## Flat 2, 26 Belsize Lane, NW3

## **Proposed Studio Details**

1118-AP04C	
Date	Scale
June 2021	1:50@A3

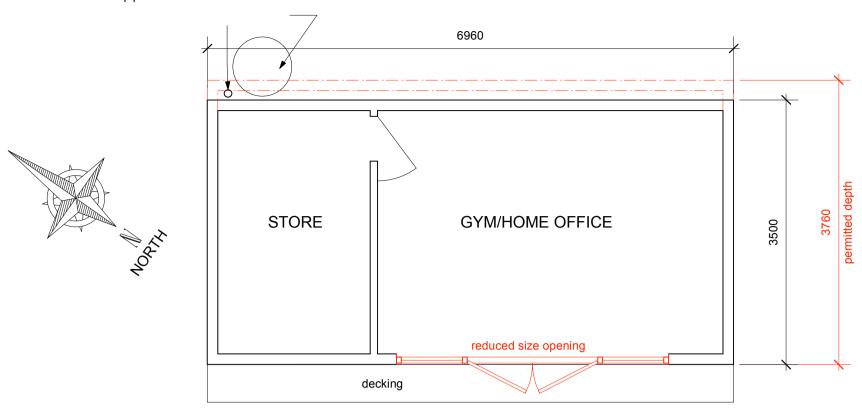
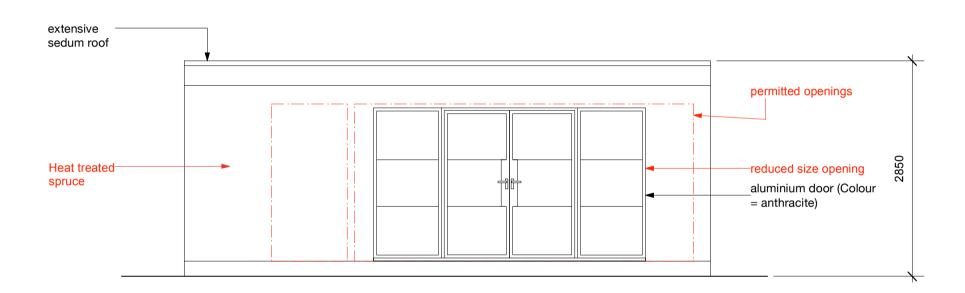
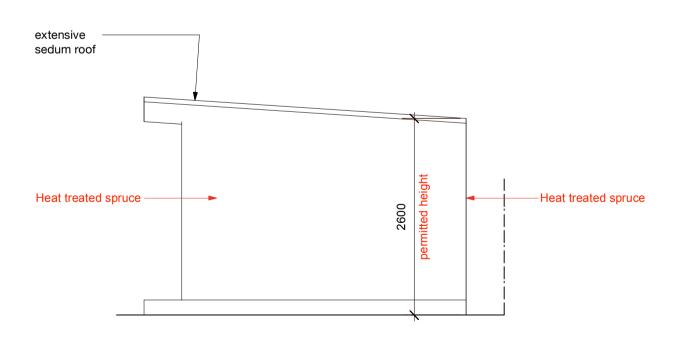
Rev A: Openings reduced in size and glazing style revised, height at rear changed from 2.6m to 2.85m, cladding changed from larch to corrugated and composite 10.06.24

**Rev B:** Height at rear changed changed back to 2.6m as permitted 13.06.24

**Rev C:** Corrugated cladding changed to spruce 14.06.24
